REQUEST FOR INFORMATION DATE: August 24, 2016 **NO.:** RFI-252

Project Name: 15051-Webster University Interdisciplinary Science Building Project No.: 15051

Subject: Final Storm Modifications

SEWER PROFILES

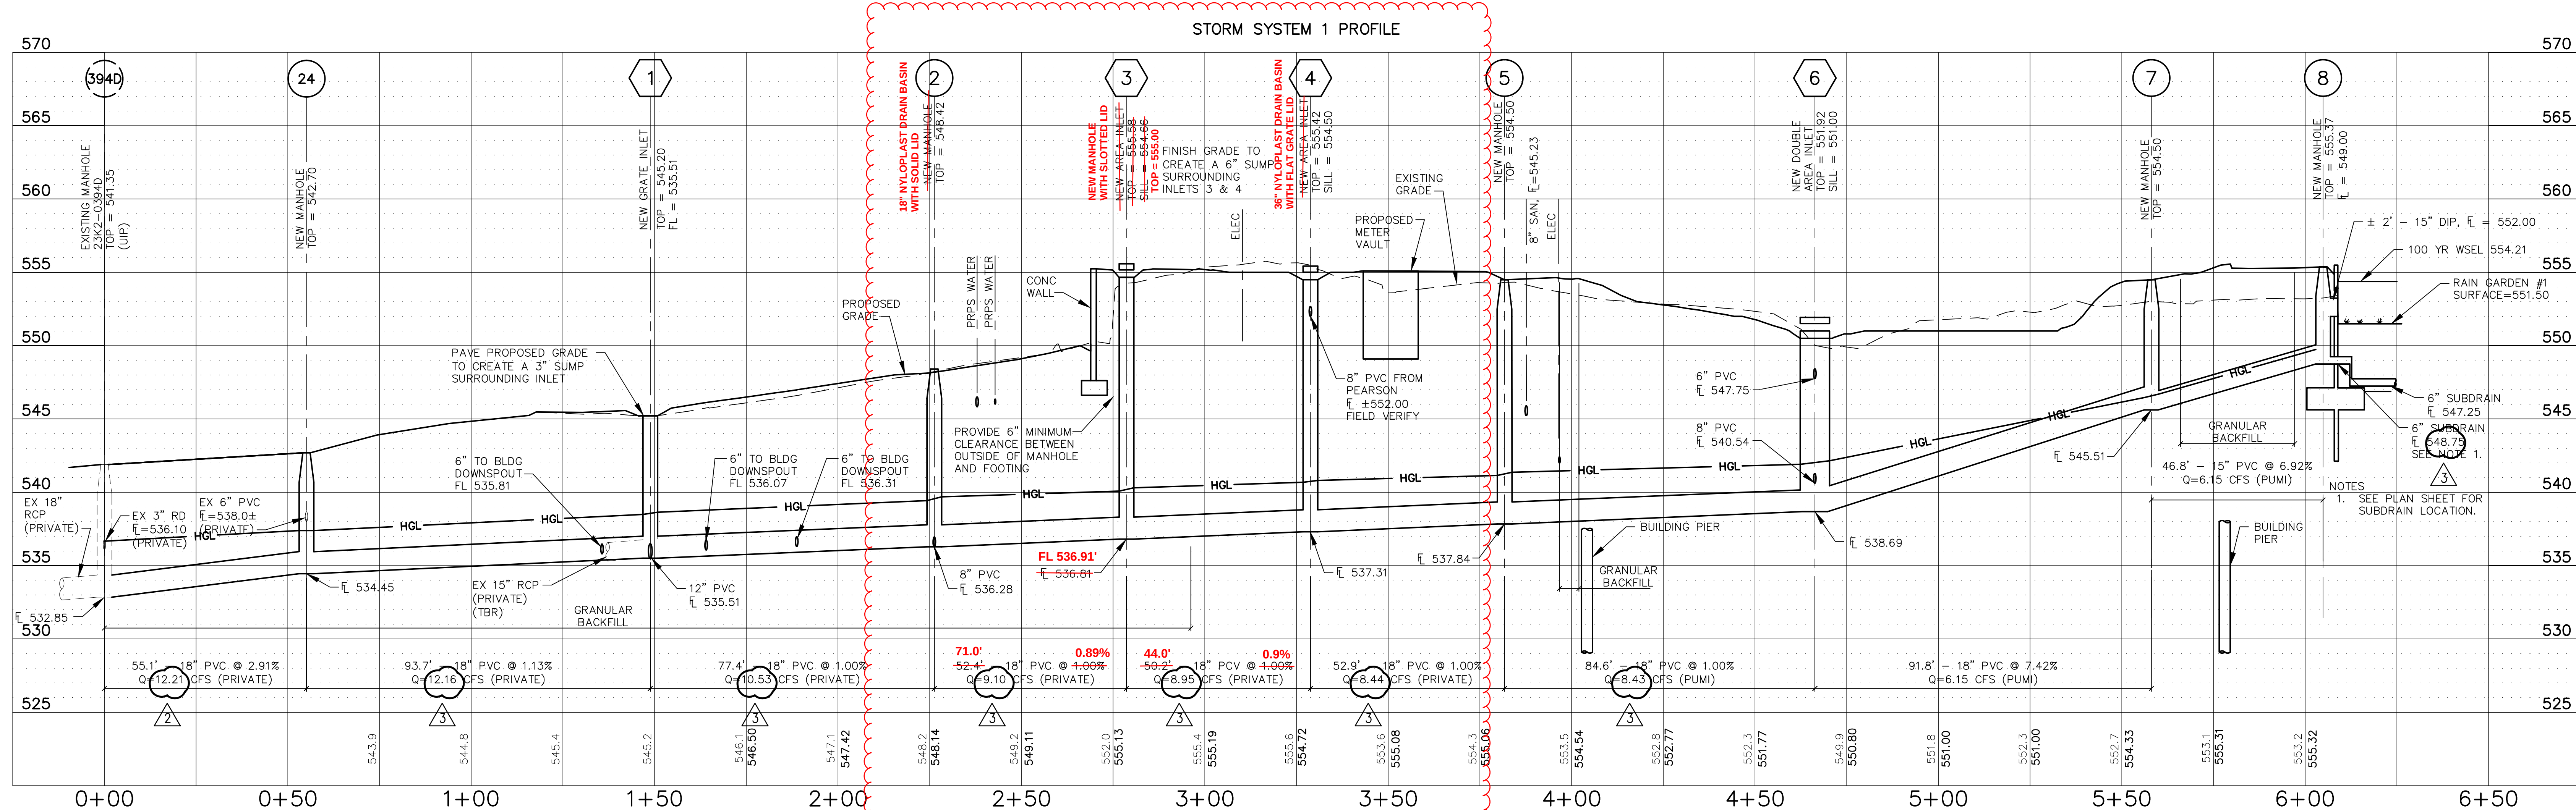
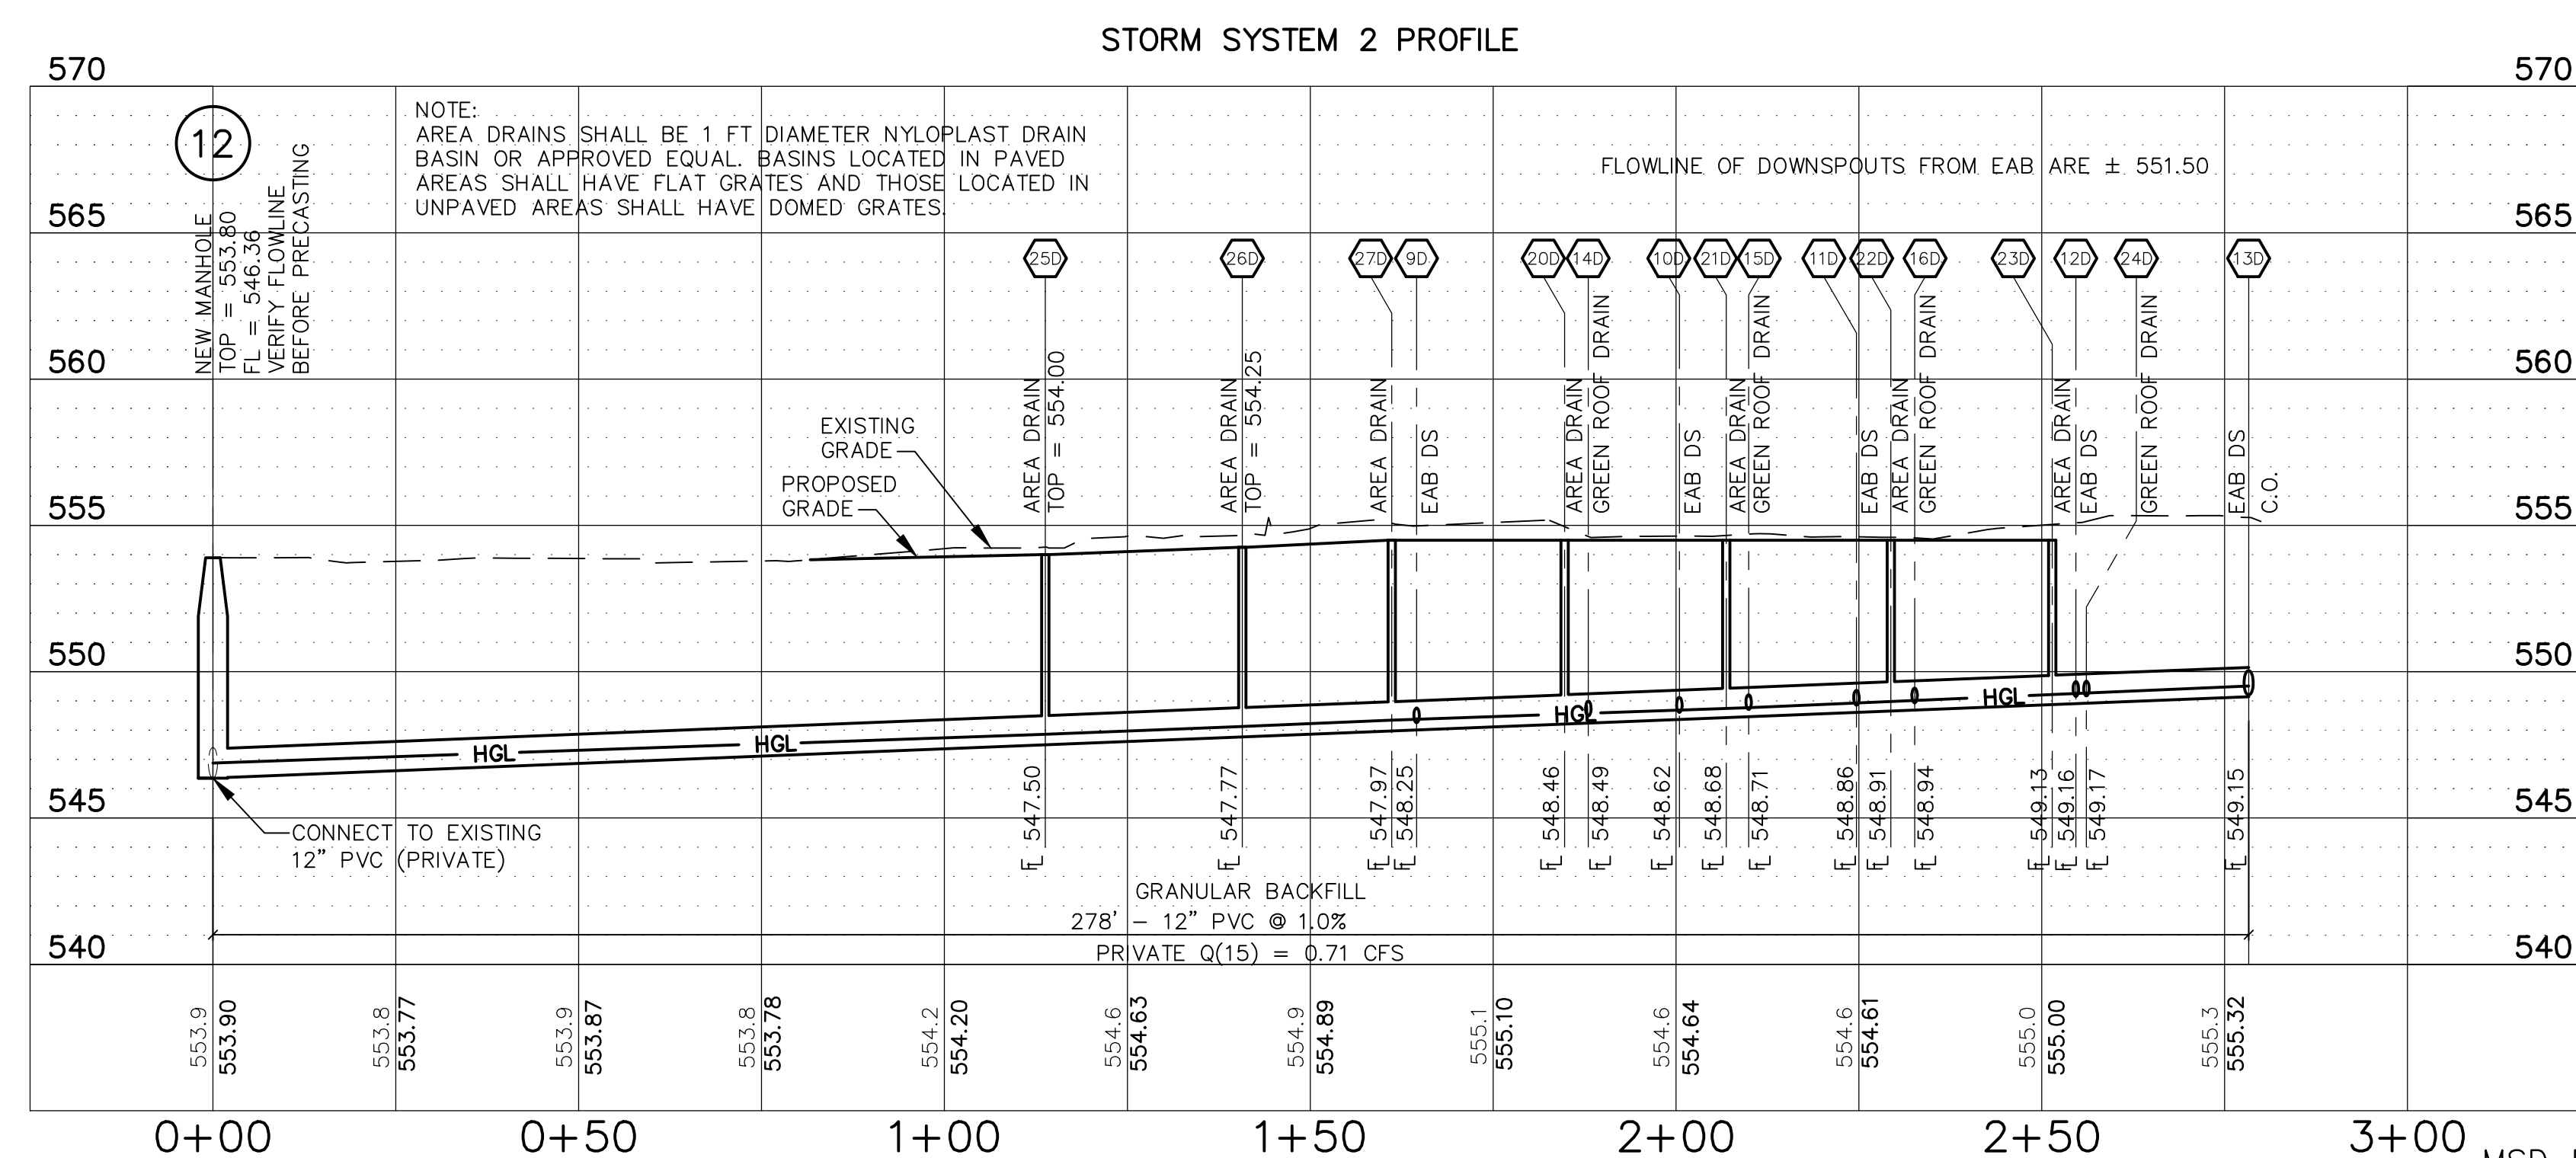
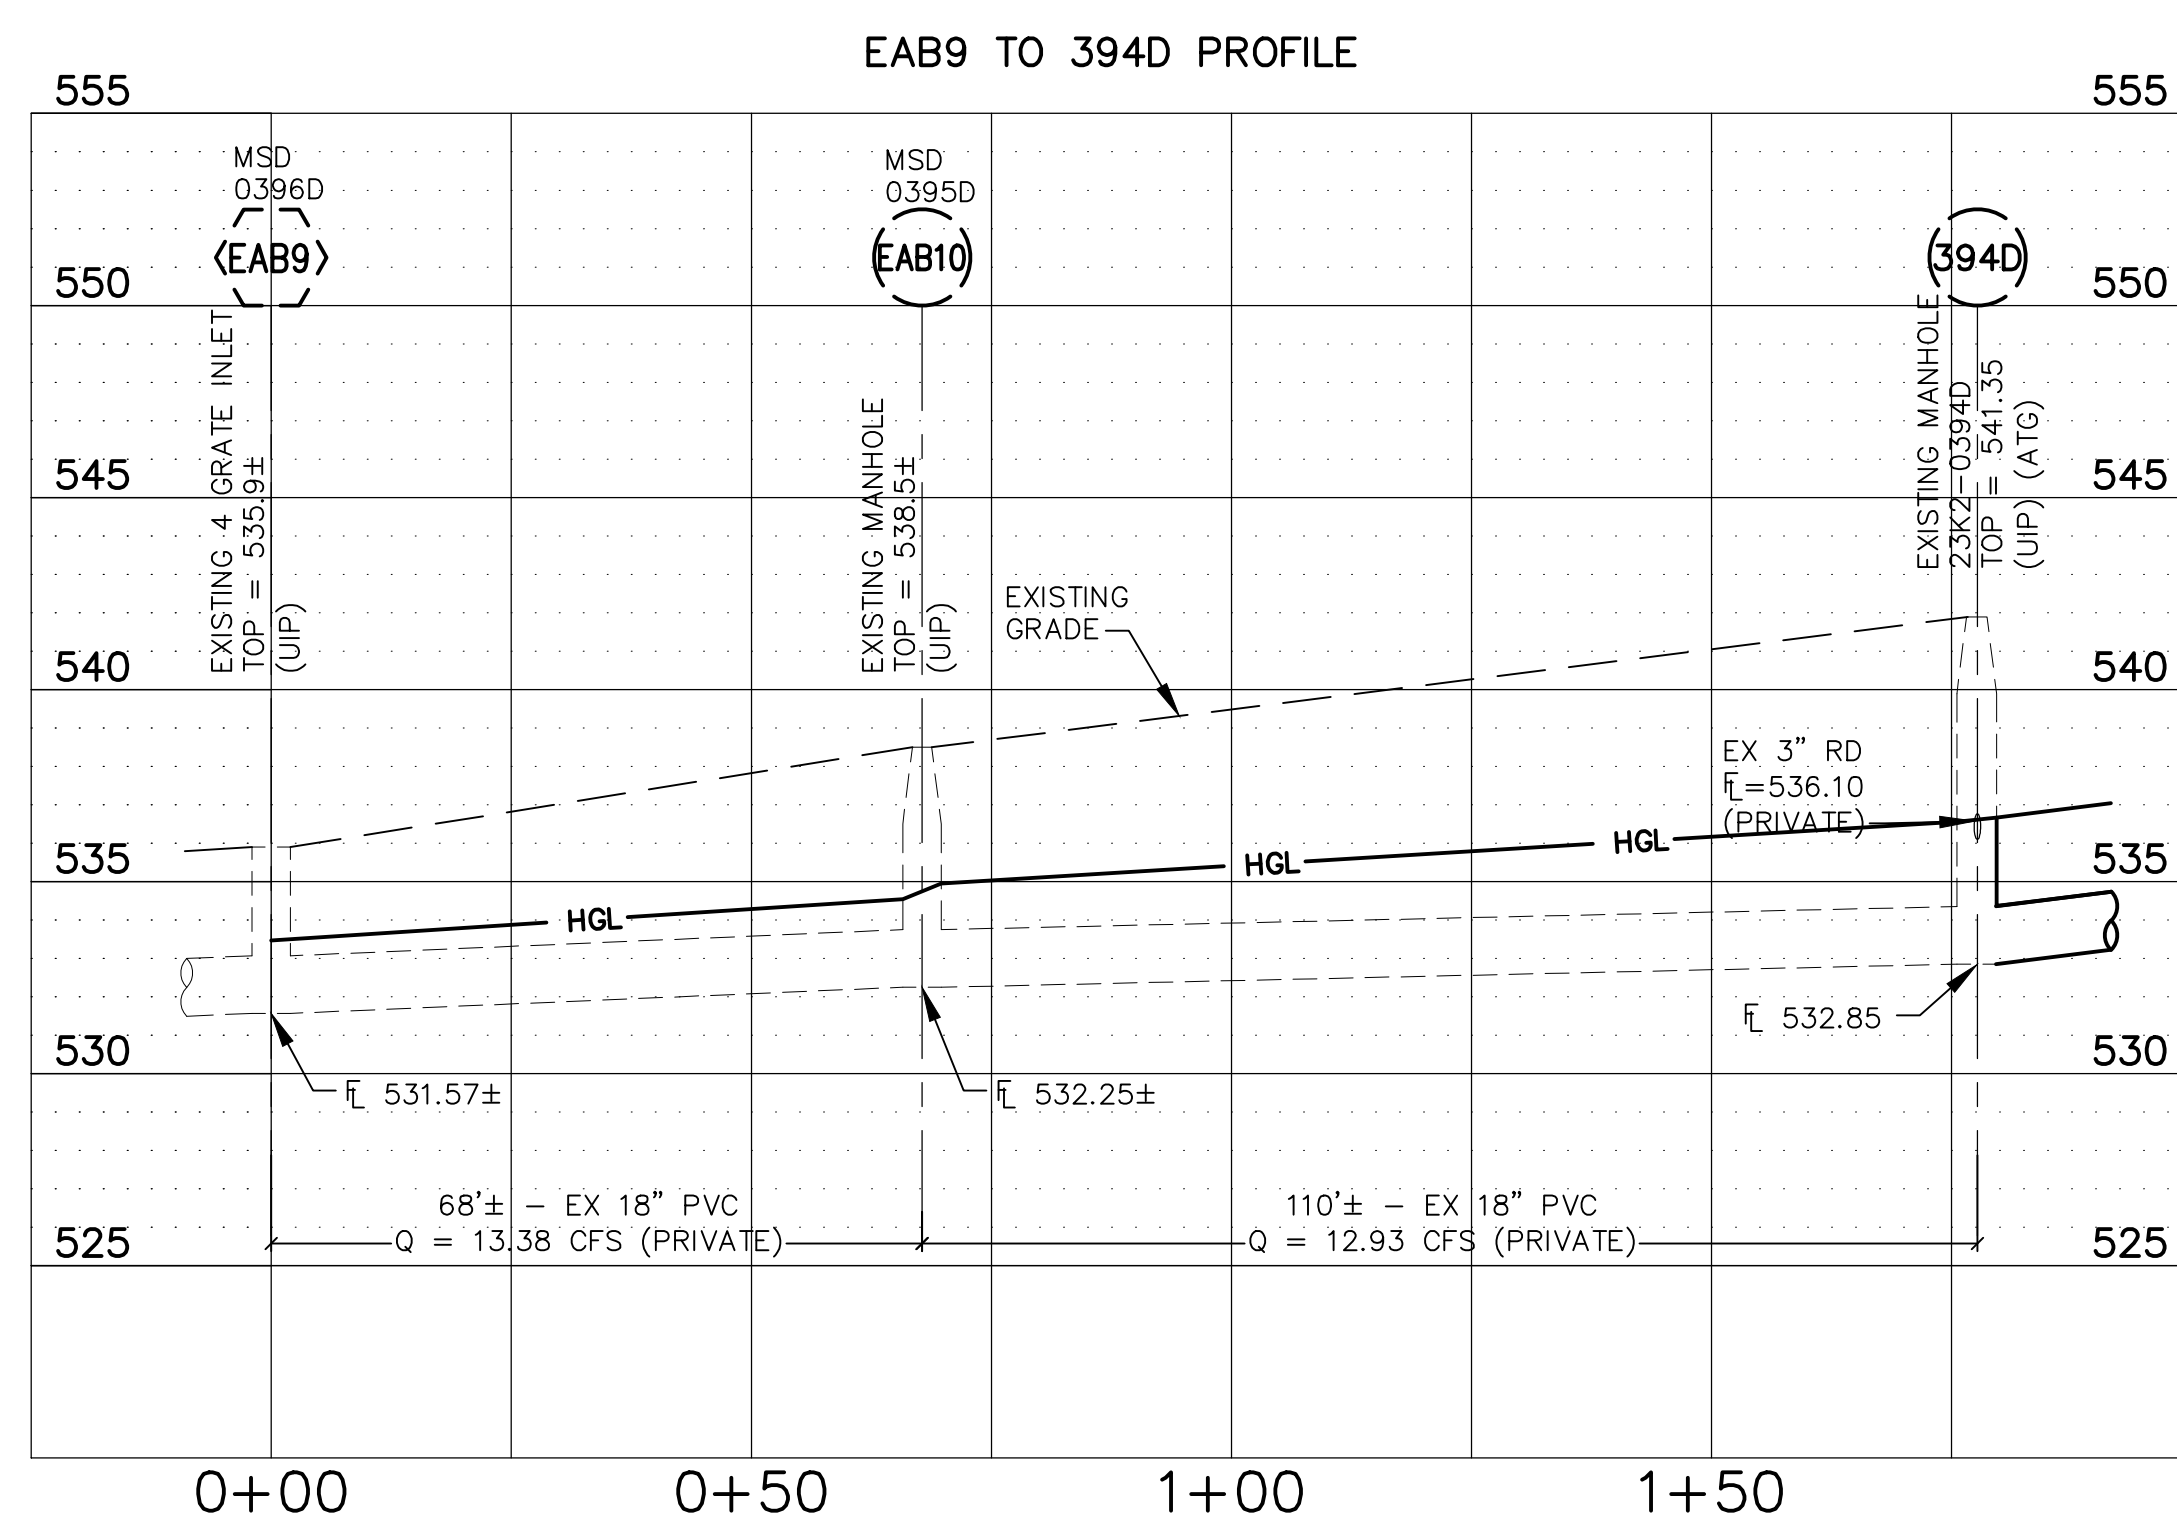
See attached markup. Please advise the modifications that have been made for constructability are acceptable.

MSD does not take exception to the suggested revisions. The pipe slope between 5 and 6 needs to be a minimum of 1%. The pipe between structures 6 and 7 needs to be lowered to avoid conflict with the rain garden. If the outgoing pipe from structure 7 is lowered to 542.00 this should provide the necessary clearance. The contractor will need to document these revisions in the as-builts set of plans submitted to MSD.
